30-September-2020

RE: Response to Technical Evaluation Comments and Information Request  
for Underground Injection Control (UIC) Permit Application  
Class VI Pre-Construction Permit Application No. R9UIC-CA6-FY20-1

### Site Characterization Evaluation of the CES-Mendota Class VI Permit Application

Figure 47: Potentiometric map of the approximate shallowest groundwater surface

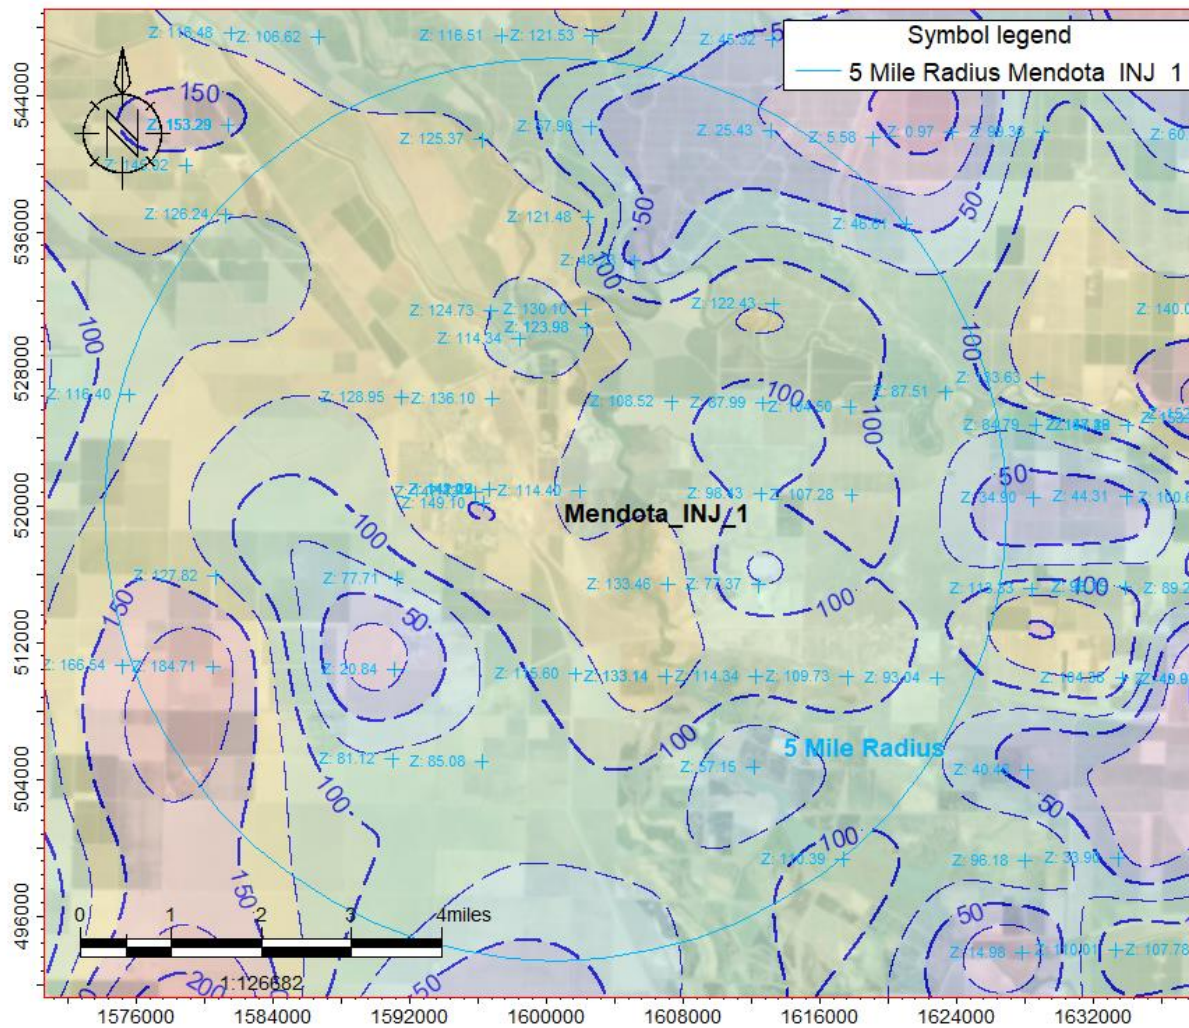
- *Please provide a legend or labeled contours for the potentiometric map in Figure 47.*
- *Figure 47: Potentiometric map of the approximate shallowest groundwater surface was updated with labeled contours. Please refer to Appendix A.*

Figure 46: Water well and surface water

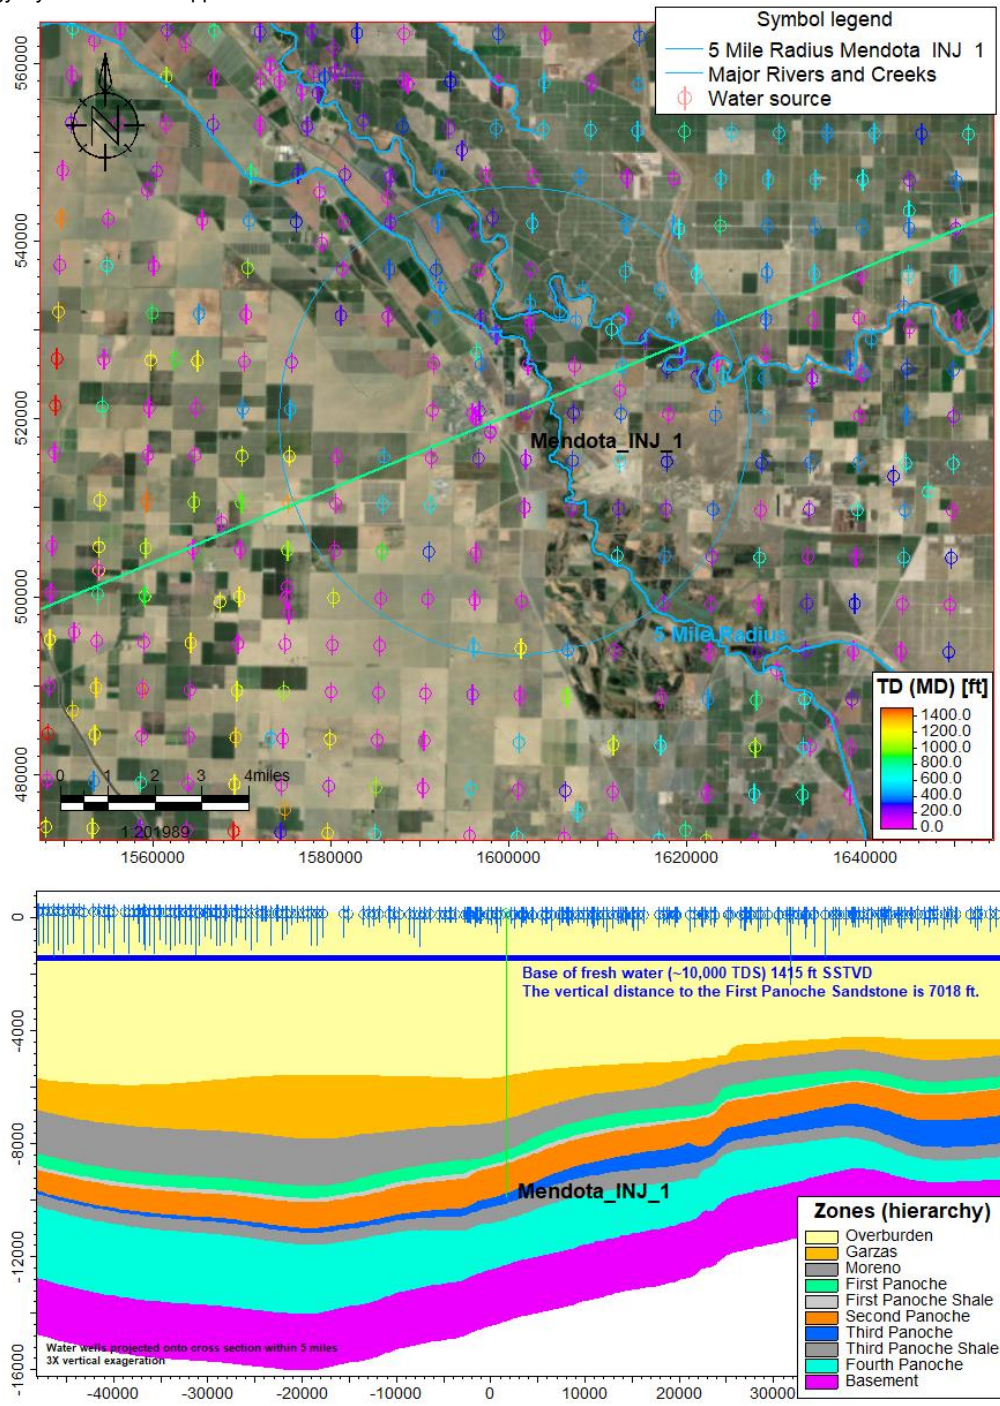
- *What is the vertical distance between the First Panoche Sands and the lowermost USDW?*
  - *At the proposed injection well location, Mendota\_INJ\_1, the vertical distance from the First Panoche Sandstone to the calculated lowermost USDW (1,415 TVDSS) (10,000 TDS) is 7,018 ft. This clarification was added to Figure 46. Please refer to Appendix A: Updated Figures.*

- *Figure 46 includes a line marking the base of fresh water at 10,000 TDS. Section 2.7.1 of the application narrative discusses a BFW of 3,000 mg/L. Please confirm that no evaluations of the lowermost USDW are based on a definition of 3,000 mg/L.*

- *The lowermost USDW in this application always refers to the 10,000 TDS limit. The California regulations of 3,000 mg/l (base of fresh water) was used as a quality control check when reviewing well reports.*
